TO	CC
Sarah Jane Brazil	Kate Higgins Tom Sloane Chris Barling Ashley Cheong
COMPANY NAME	DATE
Office of Environment and Heritage	Original Issue- 21 December, 2016 Revised Issue- 19 January 2017
FROM	PAGES
Sydney Opera House	6 pages 3 attachments
SUBJECT	
Re: Sydney Opera House Function Centre Development and Ballet Rehearsal Reallocation (SSD7665)- Heritage Council Comments 30 November 2016 [REF DOC16/534144]

Memo.

Further to the comments issued by the Heritage Council in **Sydney Opera House Function Centre Development and Ballet Rehearsal Reallocation (SSD7665)- Heritage Council Comments 30 November 2016 [REF DOC16/534144]** the Sydney Opera House wishes to make the following comments;

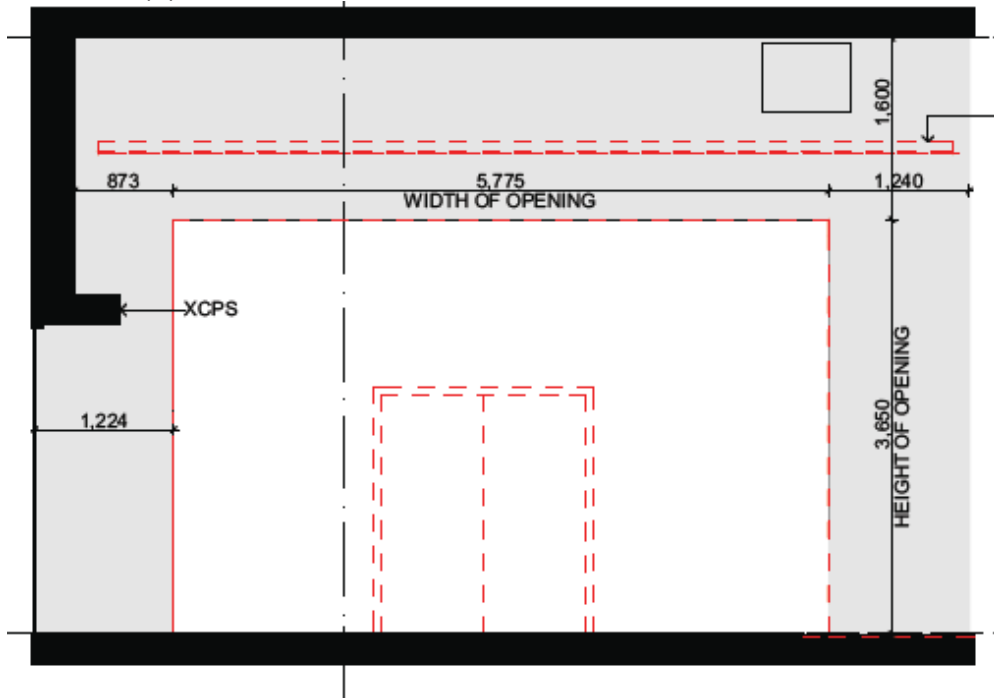
The submitted drawings show that the proposed alterations to the existing structure in order to form the three interconnected double height spaces for the function centre will require the demolition of the two existing concrete radial walls which are significant structural elements of the Podium. This will have an unacceptable impact on the significant fabric of the Opera House. It is considered that the walls must be retained and openings made within them so that a sufficient component of the original walls remain. This will provide clear evidence and understanding the original wall and spatial arrangement of the space.

It is noted that a drawing received from the Sydney Opera House on the 28 November 2016 being, Lateral Walls – Demolition – Elevations Opening being drawing no. 49 BRTZG04 (SK-04) Revision A dated 07.11.16 shows that a section of the existing walls are to be retained at the side and top.

The proposed new openings will require a significant extent of the existing radial walls to be removed. It is recommended that the size of the opening be reduced in order to retain a greater understanding of the nature of the original wall. It is noted that the applicant's heritage consultant has refrained from endorsing the proposed new openings.

FUNCTION ROOM LATERAL WALL - DEMOLITION ELEVATION EAST
1:50

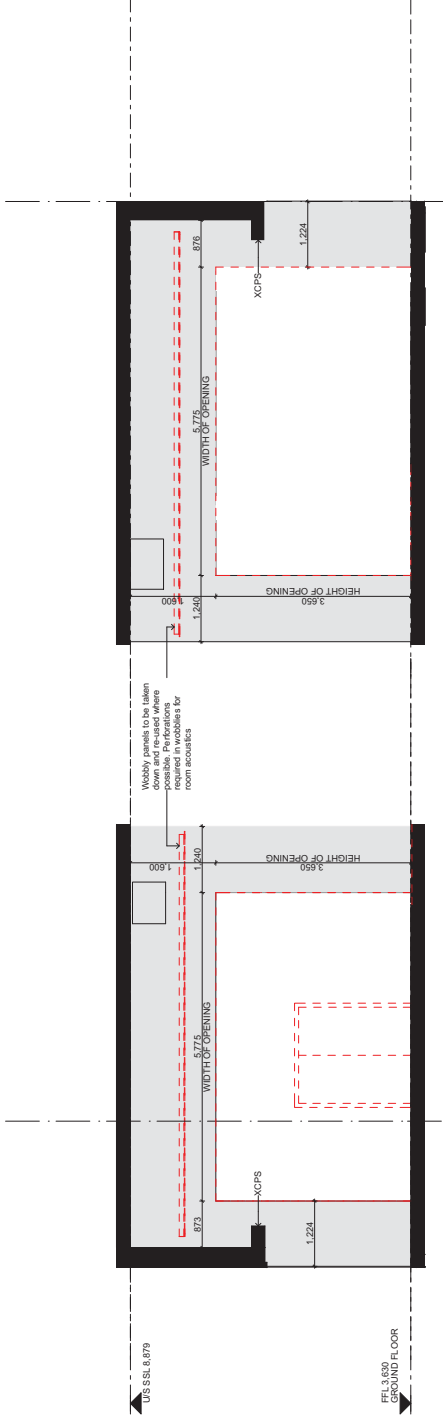
As discussed on the phone, the only change has been a reduction of 100mm in the height of the opening as a result of further detailing and refinement to the operable walls and treatment of the head track in the opening. There has been no change to the width of the opening.

Please find attached updated Demolition Elevation showing this. Visually, the change is minimal and from a heritage perspective, we will be retaining more of the existing wall.
